HISTORIC PRESERVATION REVIEW BOARD STAFF REPORT AND RECOMMENDATION

Landmark/District: Address:	Georgetown Historic District/ Lydia English's Female Seminary 2929 N Street and 1305-1315 30 th Street NW	(x) Consent calendar
Meeting Date: Case Number:	June 22, 2023 23-362	(x) Subdivision(x) Concept

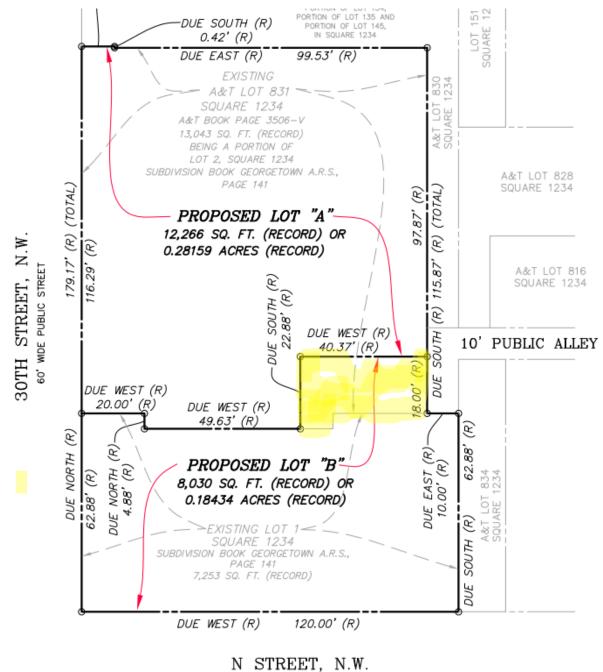
The applicants, N Street Trust and Colonial GEG LLC, the property owners of each of the two adjoining properties, request the Board's review of a conceptual subdivision application to adjust the boundary between the properties to transfer four parking spaces from 1305-1315 30th Street to the 2929 N Street, a parcel measuring roughly 20 by 40 feet in the southeast corner (rear) of 1305 30th.

While it is never ideal to alter what appears to be a historic boundary of a landmark, there are factors that mitigate harm and make the proposal consistent with the purposes of the preservation law. The landmark is a large property, extending over a second lot to the north of 1315 30th. As with that lot, 1319 30th Street, subdivision does not actually remove land from the designated landmark or alter its boundary. Although there could be eventual consequences, such as a fence or wall proposed within the transferred area, the property remains subject to review under the District of Columbia's preservation law as both a landmark and a property contributing to the Georgetown Historic District. It also remains subject to the Old Georgetown Act and Commission of Fine Arts review. In the meantime, the small parcel is to remain a portion of a surrounding parking lot and, being within side and rear yards, it offers little potential for construction.

Putting a property boundary right behind a wing of the landmark building can have practical consequences, such as constraining emergency egress from adjacent windows. But this may be more of a problem on paper—that is, in the building code and on the plat itself—as an only-two-foot-wide path is anticipated, but the subdivided piece is to remain an open parking lot for the foreseeable future.

HPO recommends that the Board approve the subdivision in concept as compatible with the character of the historic district and sufficiently retentive of the character of the landmark, because it offers no physical alteration of the properties and admits only limited potential for it in the future, subject to robust preservation review.
